Objection to Planning Application Reference: **DC/26/0616**

Address: 82 Bedford Road, Horsham, West Sussex RH13 5BH

Proposal: Erection of a single storey rear extension.

Fig. 1 Proposed Site Boundary - red line Fig. 2 Actual Site Boundary – dashed blue line

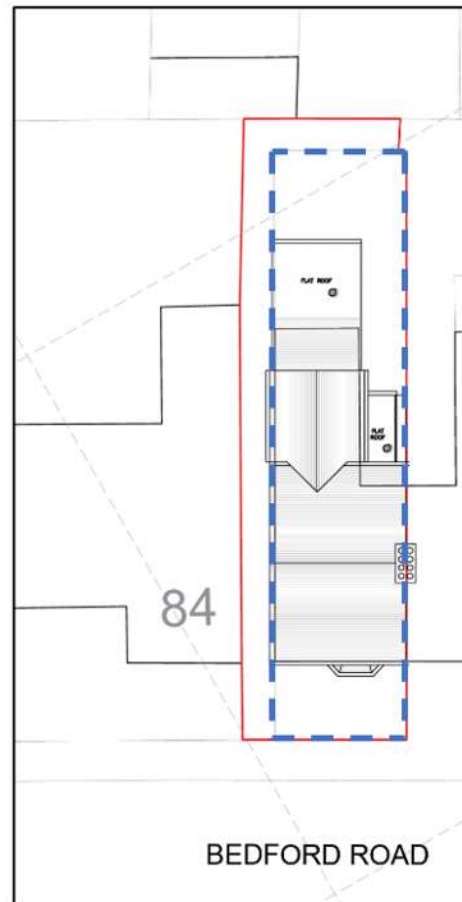
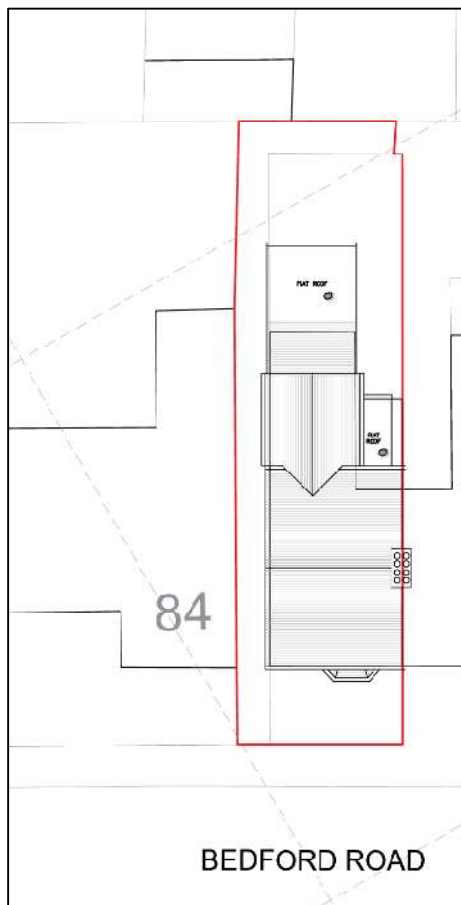
The application form provides a Certificate of Ownership – Certificate A indicating that the applicant owns the whole site. However, in the drawing – *LP001 - Proposed OS Map and Location Plan* – the red-line application site boundary (see Fig. 1 below) includes the side and rear passage despite these areas not forming part of the legal site boundary of 82 Bedford Road. As a result, the plot appears substantially larger than it is in reality which understates the impact of the proposed extensions on the remaining outdoor amenity space.

When the correct site boundary is applied (see Fig. 2 above – dashed blue line) the amount of remaining garden and amenity space is inadequate for the proposed level of occupancy. This is particularly concerning given the intended high-density occupancy of 6 adults (and

The inclusion of land outside the applicant's ownership within the red-line boundary also raises concerns regarding the accuracy of the submitted ownership certificate and whether the application has been correctly validated.

Fig. 4 – Side Elevation showing Side and Rear Extension

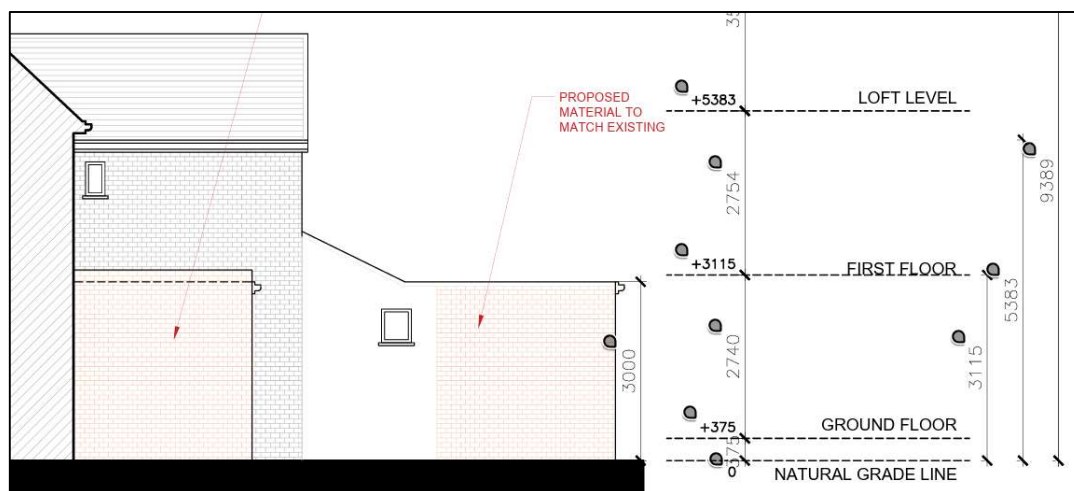
The side wall of the proposed extension, which is located along the shared boundary with No. 80 Bedford Road, appears on drawing P003 – *Proposed Side Elevations* to be approximately 3.27 metres in height (see Fig. 4 below). This is shown in relation to the boundary treatment and existing neighbouring context.

Under Class A permitted development rights for single-storey side extensions, the maximum permitted height at the boundary is generally 3 metres. On the basis of the submitted drawings it is therefore unclear how the proposed side extension is considered to fall within permitted development limits.

In addition, it is noted that it is not included for permission in application DC/26/0616 and no separate planning application has been submitted for this element of the development. If the side extension does not fall within permitted development rights, it would require full planning permission as part of the current application.
